S E R V I C E N O T E

**37717A PDH/SDH Test Set**

**Mechanical Shock can disconnect output cable from PDH Tx Assembly.**

**Figure 1 - Showing Preferred Route for cable A7 J4 to Module Front Panel**

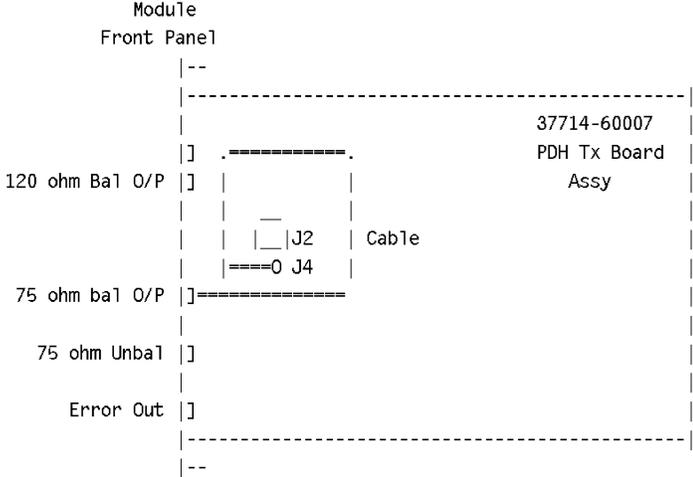
37717A instruments in the above serial range are prone to losing the 75 ohm PDH transmit signal.

This is caused by the connector and cable which carries this signal to the PDH Tx/Rx Module front panel becoming detached from the socket on the PDH Tx Board Assembly.

If any of these units are encountered (see above for list of serial numbers) the hardware modification described below should be performed. This involves removing the PDH Module from the instrument, then separating the Tx and Rx board assemblies to allow access to cable A7 J4. This cable is then re-routed in such a way as to avoid relay A7 K2 which is responsible for separating the cable plug from J4 when the cable is turned.
